ADDENDUM NO. 1

TO: PLANS AND SPECIFICATIONS FOR STATE OF MISSOURI

**Renovate Lobby and Restrooms 1st and 2nd Floor
Howerton State office Building
Jefferson City, Missouri
PROJECT NO.: O2339-01**

3 FIRST FLOOR RESTROOM ENLARGED DEMOLITION PLAN
SCALE: 3/8"=1'-0"

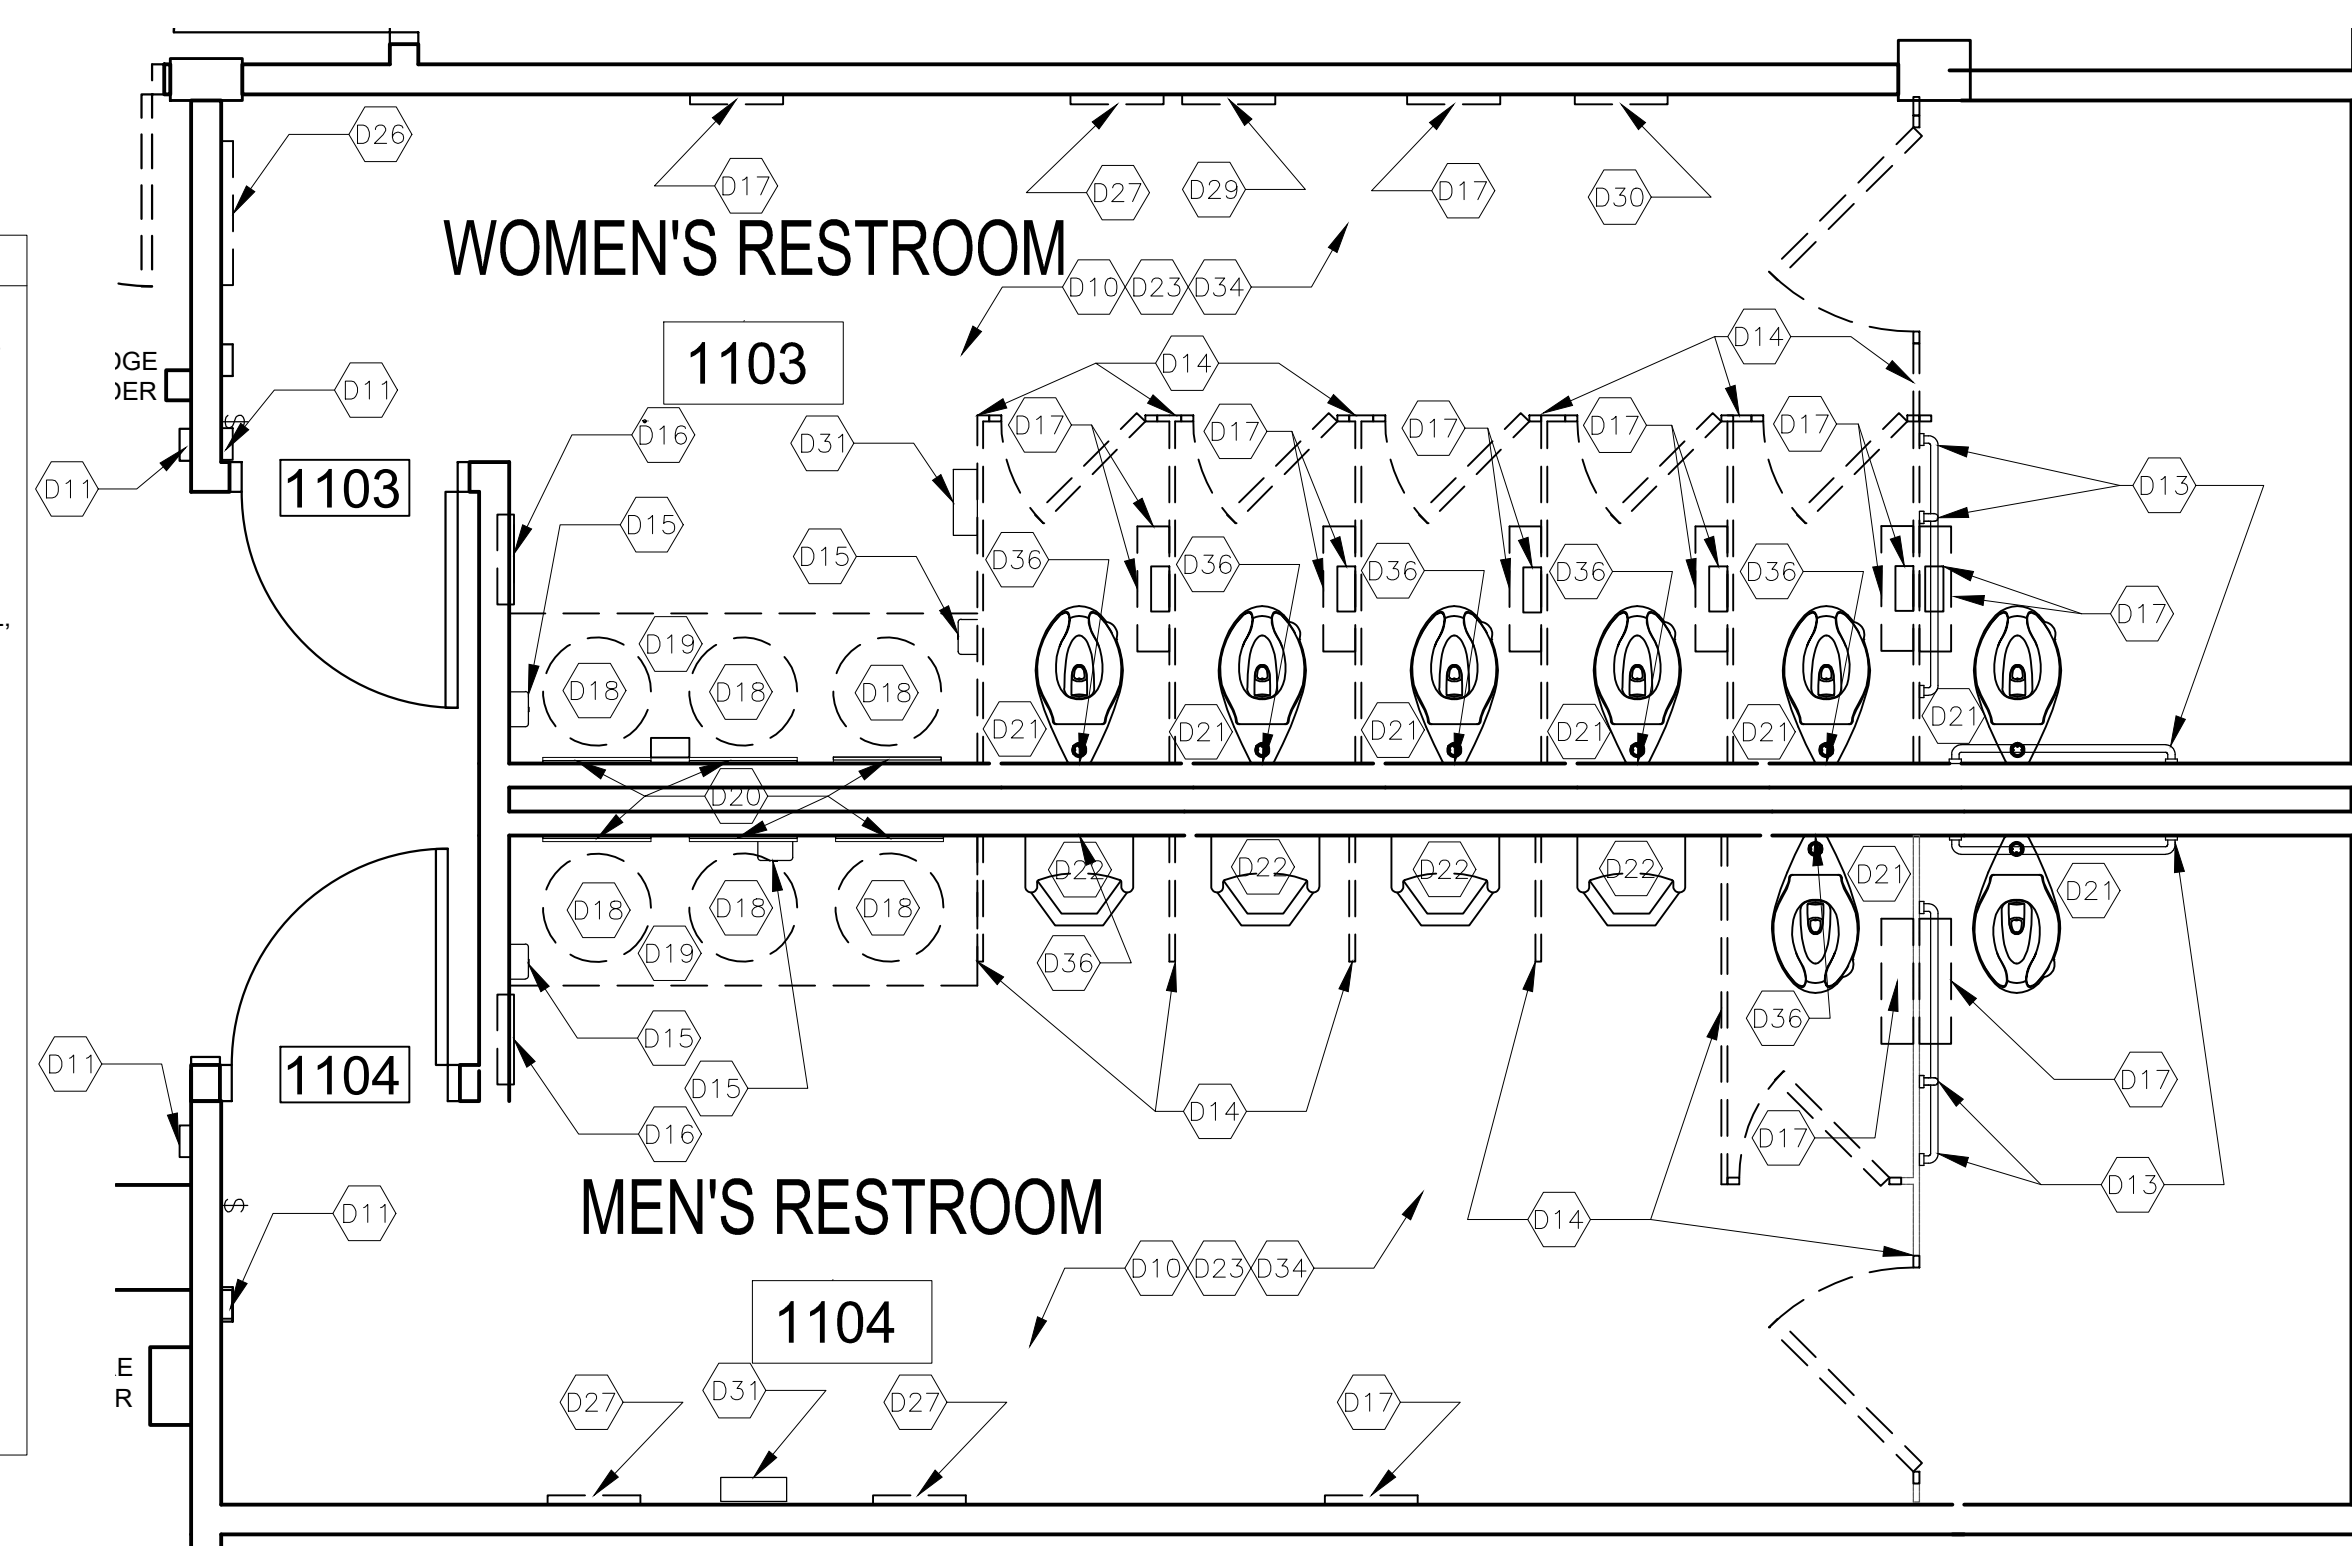
A-100

2. Demolition Plan Tag Note "D15" updated. No save for reuse.
3. Demolition Plan Tag Note "D16" updated. No save for re-use in same location.
4. Wall Symbol Key. Change demountable walls (existing base trim to be reused) to new walls. Change fixed gypsum metal studded walls (vinyl base cove to be replaced) to existing walls.

SHEET TITLE:
**SECOND FLOOR
LOBBY & RESTROOM
DEMOLITION PLAN**

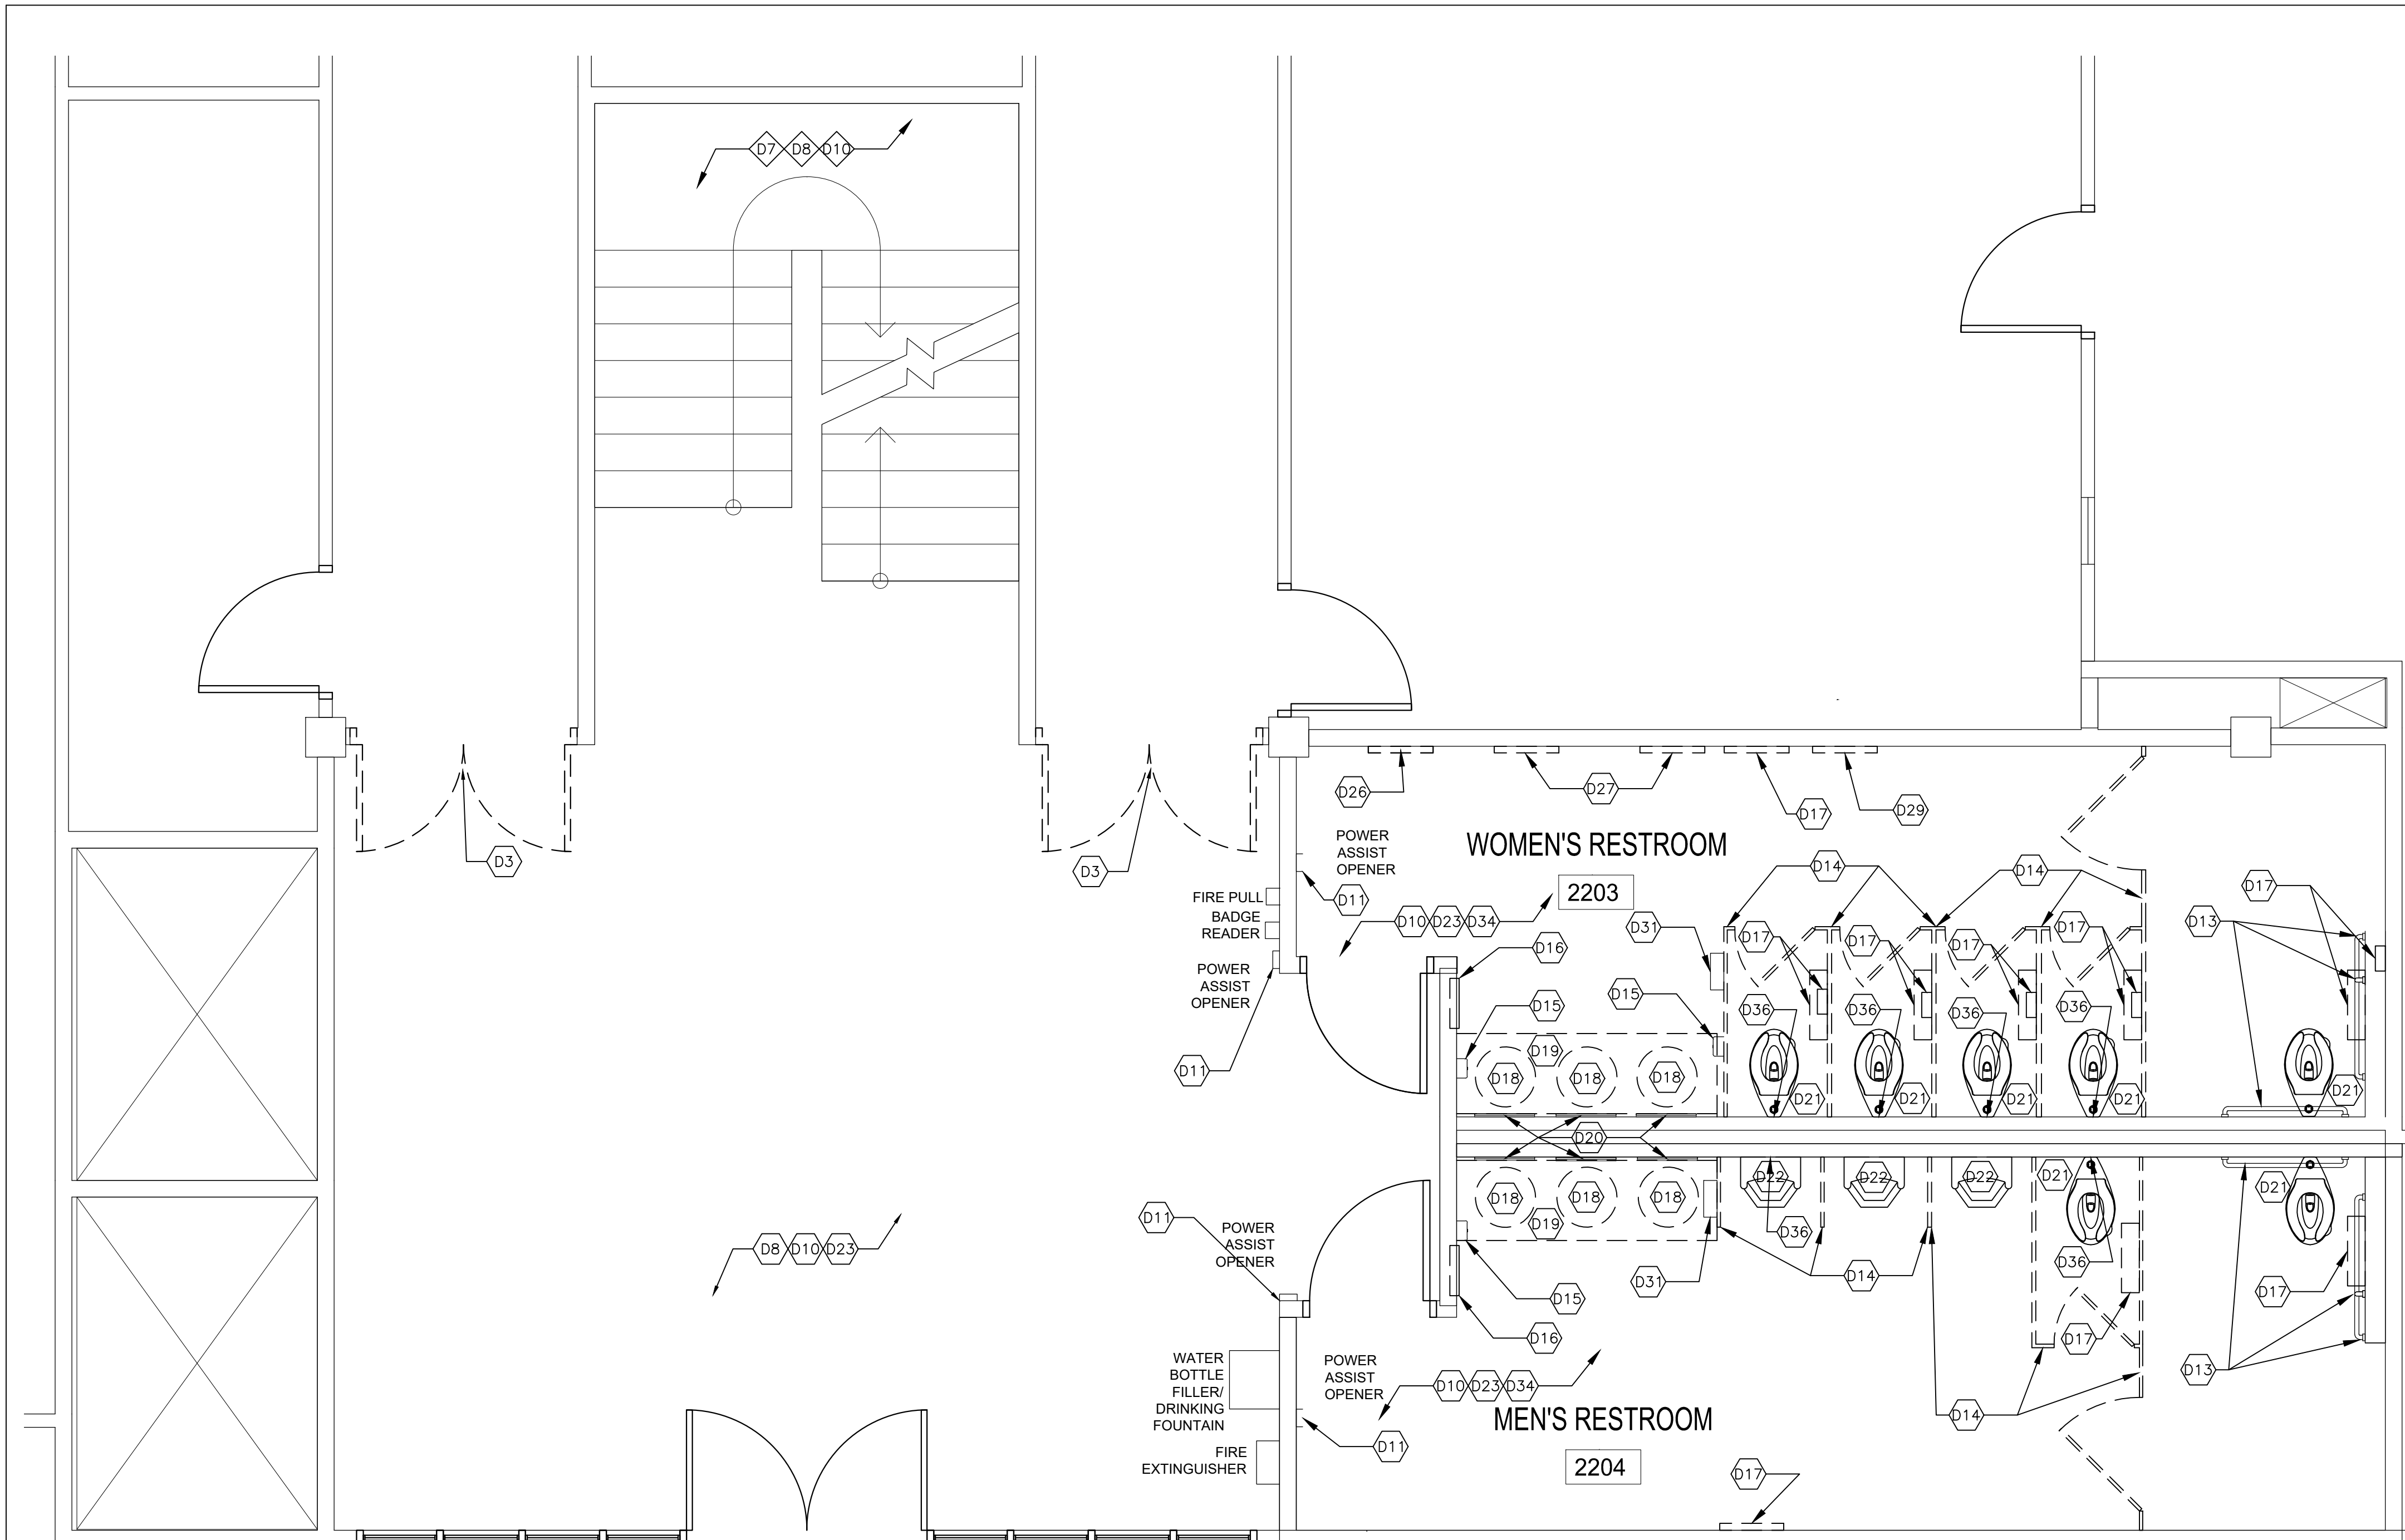
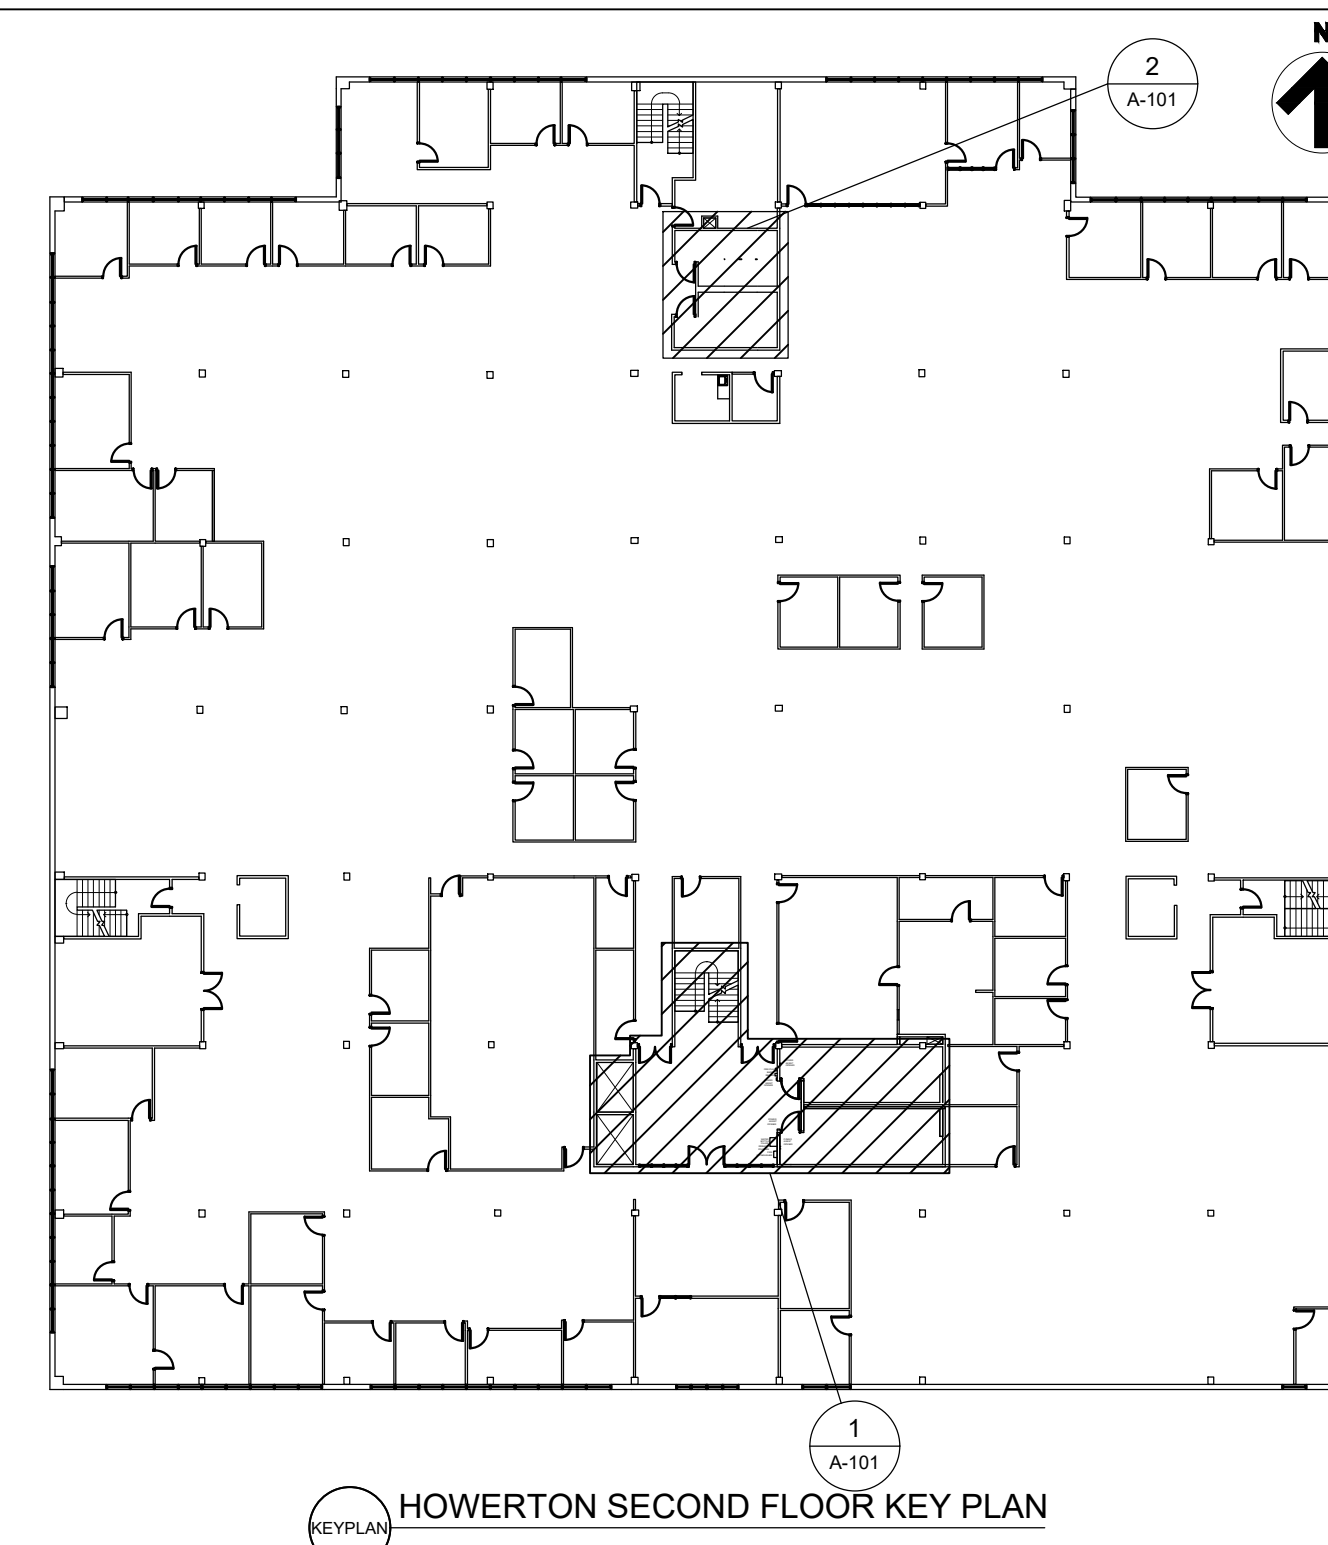
A-101

1. Key Note "D15" updated. No save for reuse.
2. Key Note "D16" updated. No save for re-use in same location.
3. Keyed Noted on drawing 2 – Second Floor Staff Restroom Demolition Plan labeled as "8" should be keyed note "D20."
